SERVICE BULLETIN

No. 526A

Piper Aircraft Corporation

Subject: Pilot/Copilot Microphone and Phone Jack Relay Modification

PILOT/COPILOT MIKE AND PHONE JACK RELAY DETAIL

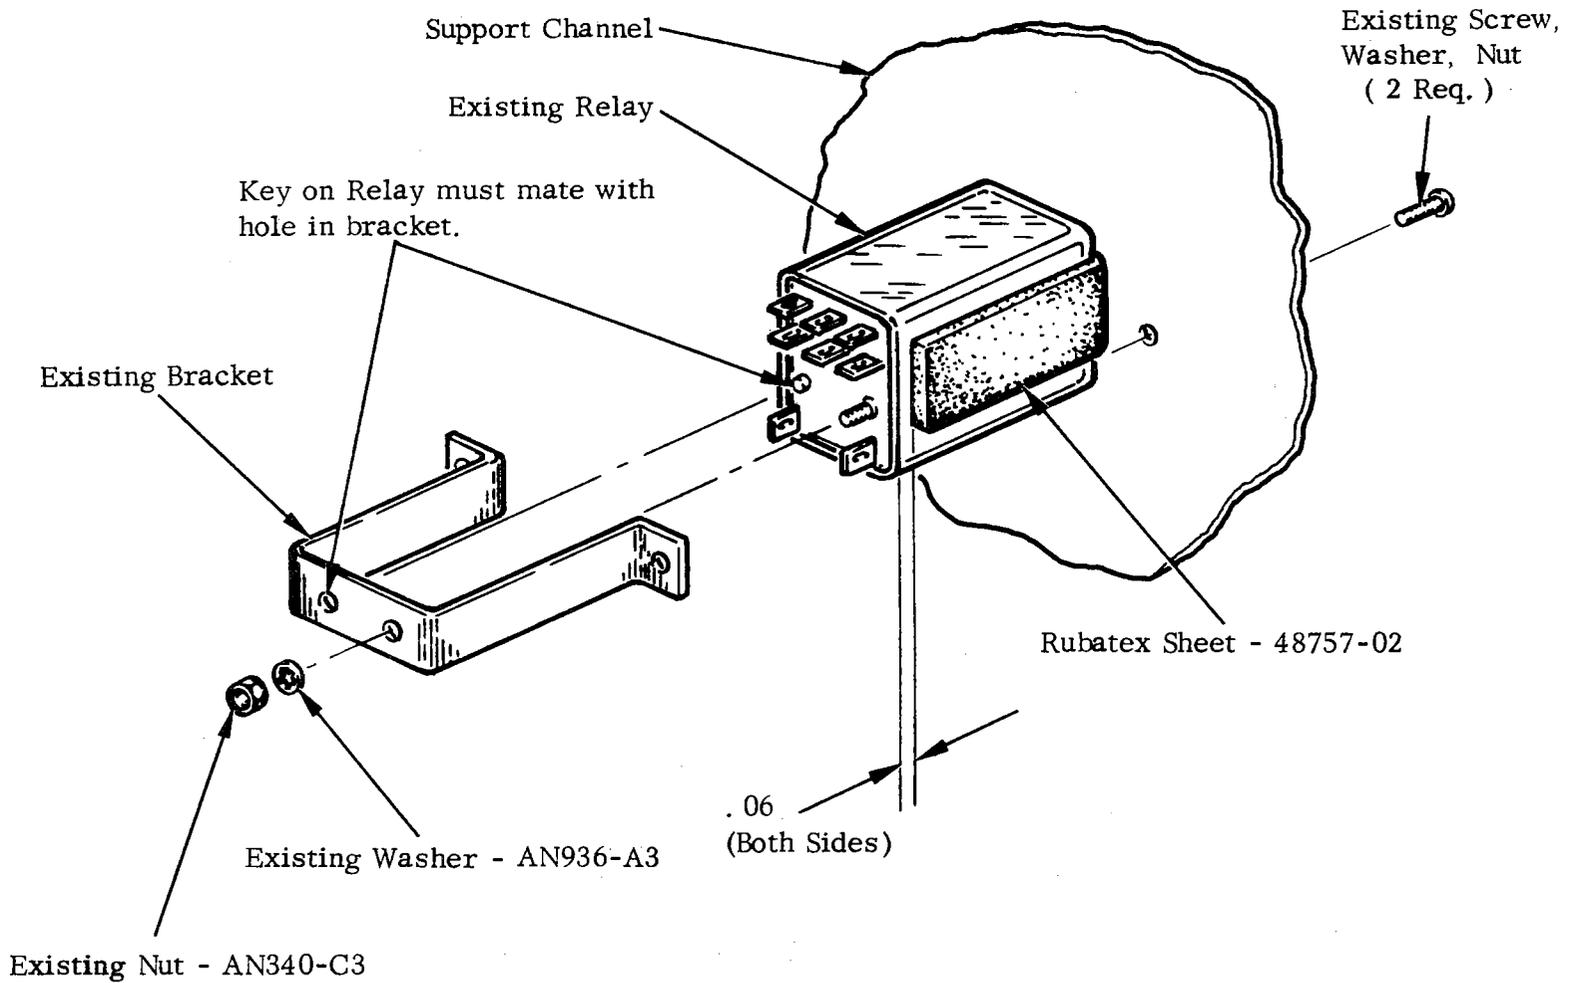
Purpose: Intermittent operation of the copilot's microphone was determined to have occurred as a result of the pilot/copilot's microphone and phone jack relay loosening (through vibration) from its mounting bracket. This can, in turn, cause the 28 volt pin on the relay coil to contact the mounting bracket, causing an electrical short.

This Service Release provides material and instructions for applying a rubber strip to the relay assembly, to dampen vibration and increase the rigidity of the mounting bracket.

1. Ensure master switch is off.
2. Locate pilot/copilot mike and phone jack relay, as shown in detail above. The relay will be located near the copilots mike and phone jack.
3. Remove relay and attaching bracket as one unit. Retain hardware for reinstallation.
4. Disconnect relay from bracket. Retain washer and nut for reinstallation.
5. Wrap rubatex sheet 48757-02 around relay and trim to dimension shown above. Attach existing relay, with rubatex sheet, to existing bracket as shown using existing nut and washer.
6. Reinstall switch and bracket assembly to aircraft using existing hardware.
7. Make proper logbook entry of Service Bulletin 526A Compliance .
